CELL : A467	CELL NAME : Tensioner Assy.	M/C STAGE: Winding/Assy.	OPERATION: Winding
--------------------	------------------------------------	---------------------------------	---------------------------

KAIZEN THEME : To Eliminate minor of A467 Tensioner Assy. on account of Winding Pin

KAIZEN IDEA : Winding Pin locating step length to be reduce by from 7mm to 5 mm

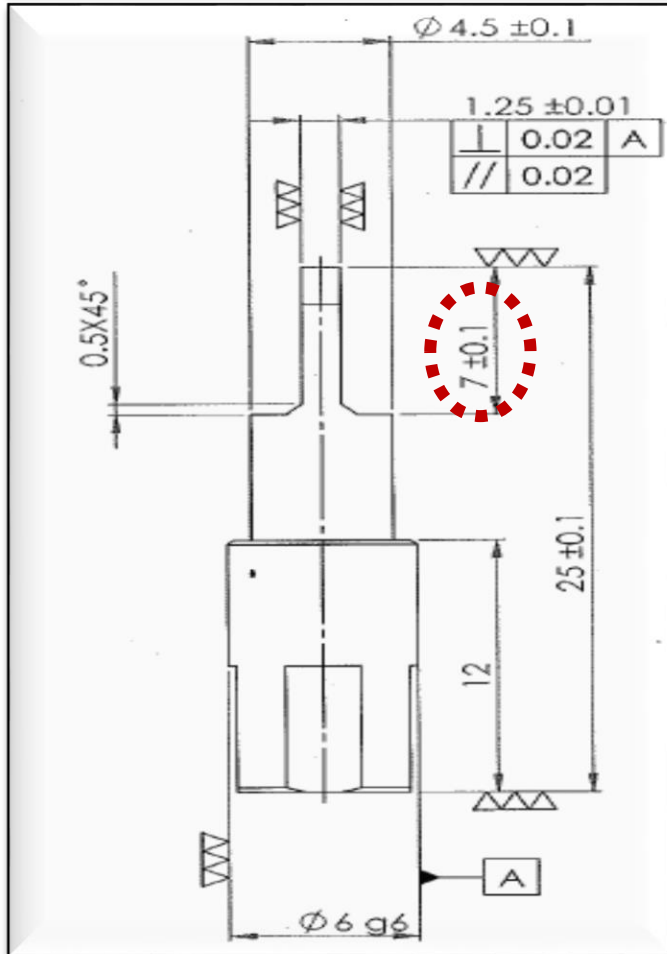
PROBLEM PRESENT STATUS : Presently winding pin twisting 2 times in a Shift.	COUNTERMEASURE: Revised winding pin locating step length from 7 mm to 5 mm & Now screw properly resting on winding in & there is load on Screw locating portion of winding pin	BENCHMARK: 02 Nos
--	---	--------------------------

Why4:- Winding pin locating Step length is more (7 mm)			One Action
--	--	--	------------

Winding pin locating Step length is more (7 mm)		WHAT TO DO: Winding Pin Drawing to be Revise
---	--	---
